APPENDIX K: ONTARIO ONE CALL REQUESTS AND RESPONSES

THE UTILITY LOCATIONS REQUEST IS FOR THE MOUNT JOY CREEK FLOOD MITIGATION MUNICIPAL CLASS

APPENDIX M: TRCA COMMENT RESPONSE LETTER

Aquafor has prepared responses to the Toronto and Region Conservation Authority's (TRCA) comments received on May 15th, 2026 (TRCA Comments) for the submission of the final Environmental Assessment (EA) study for Mount Joy Creek Flood Mitigation. Comment numbering follows the same order as the comments listed in the TRCA's May 15th, 2026 email.

Rogers File # - R250203

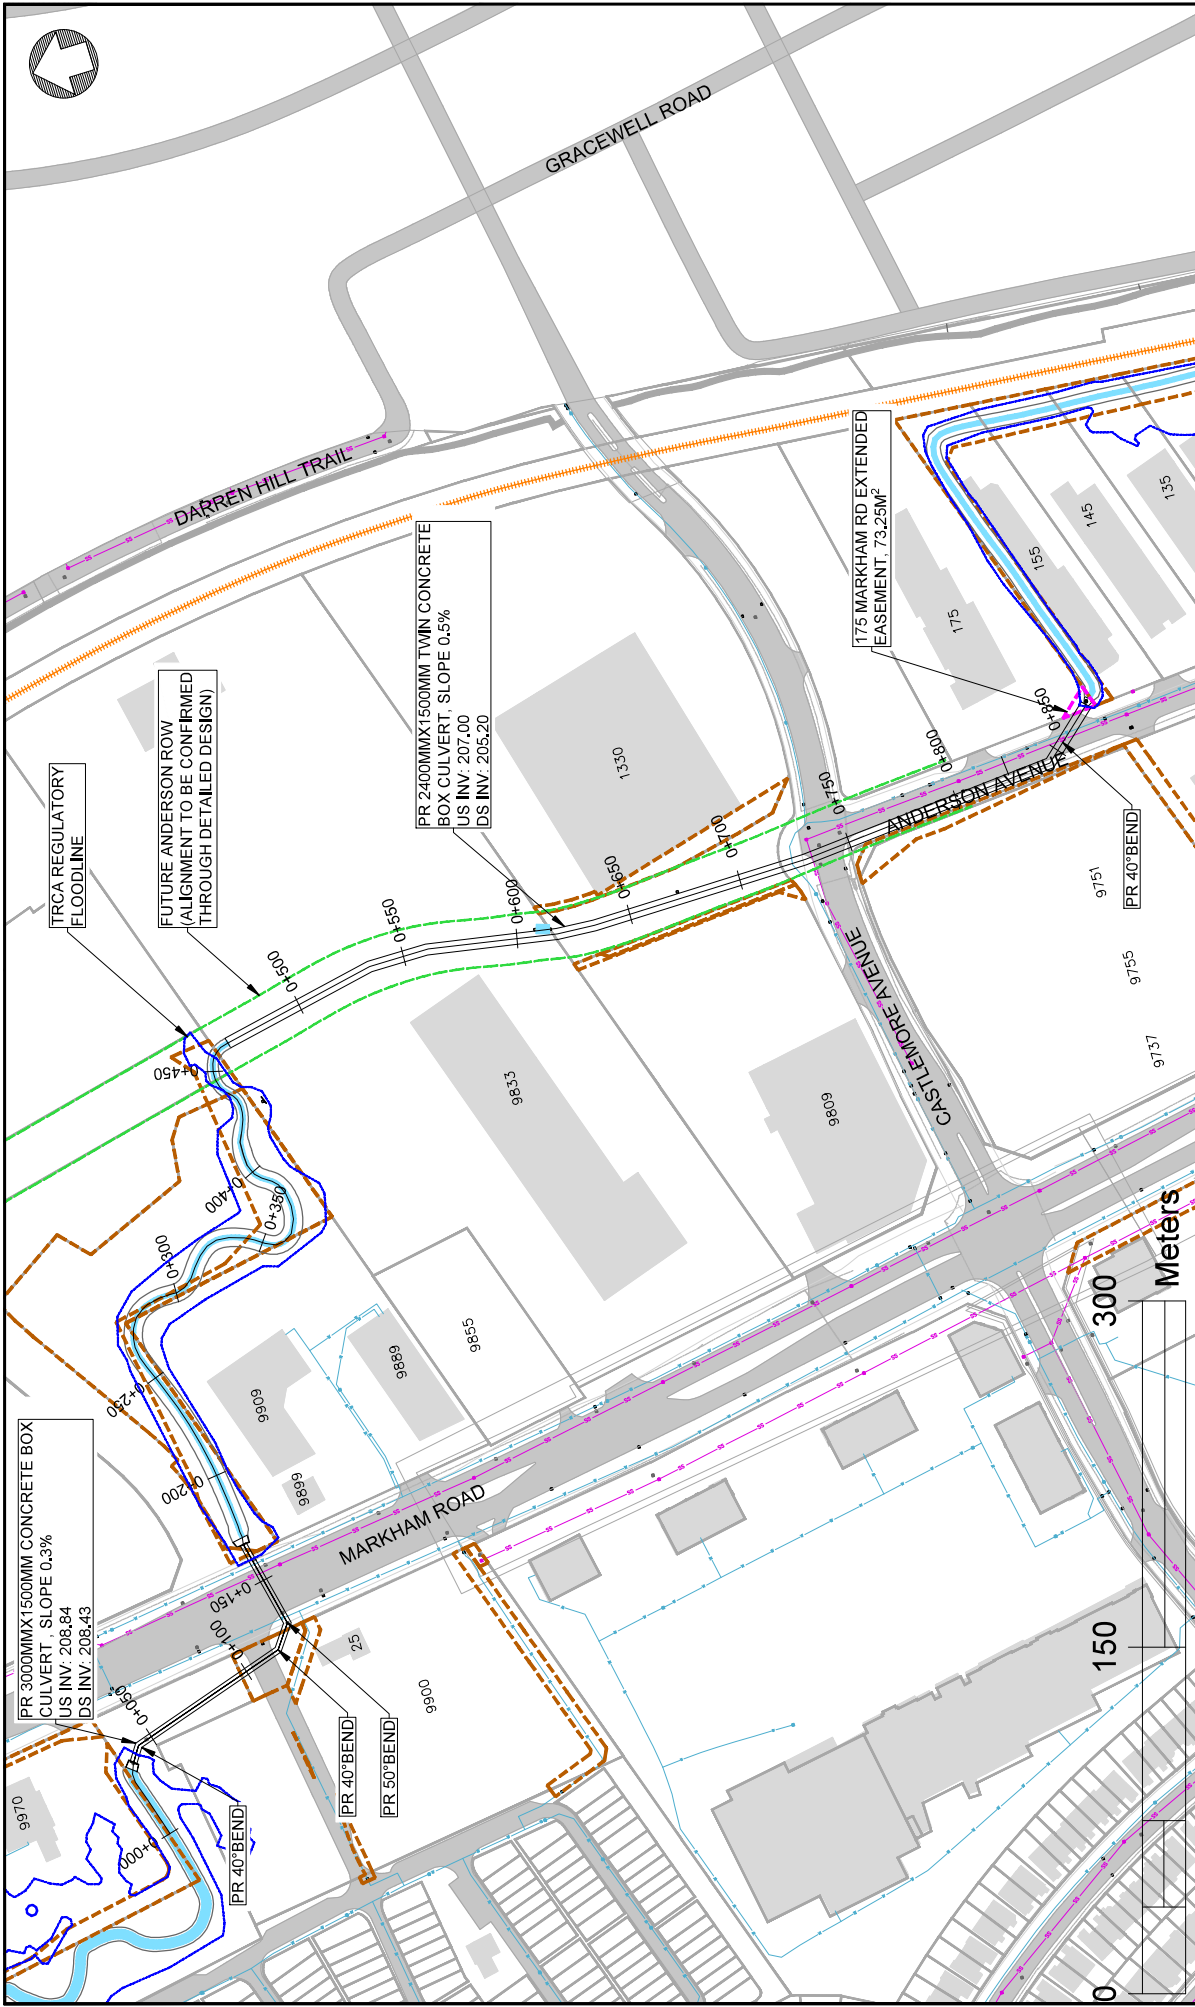
- ☒ **Markup Only** Not for PUCC Approval
- ☒ **For your Reference** Rogers Communications currently has existing plant as marked on your drawing. Our standard offset in this municipality is: **1.75m P/L on Regional Roads & 2.3m P/L on town Roads.** Please ensure you maintain clearances of 0.3 m vertically and 1 m horizontally. For hand dig maintain 0.6 m and for directional bore maintain 1.0 m horizontally.
- ☐ **No Conflict** Rogers Communications currently does not possess existing plant in the area indicated on your attached plans.
- ☐ **CONFLICT** Your proposed construction appears to encroach within existing Rogers Communications plant. Please ensure you maintain clearances of 0.3 m vertically and 1 m horizontally. For hand dig maintain 0.6 m and for directional bore maintain 1.0 m horizontally. Please relocate your proposed construction to allow adequate clearance.

- ☐ Use vactruck and expose ducts, maintain minimum of 0.6m clearance.
- ☒ Rogers Communications has aerial plant in this area, as it is indicated on the attached plans.
- ☒ Fiber Optic Cable is present in the area of your proposed construction. Please obtain locates and maintain minimum 1.0m/1.0m clearance.
- ☐ Proposed Fiber Optic Cable in a joint use duct structure .
- ☒ Plant currently under construction.
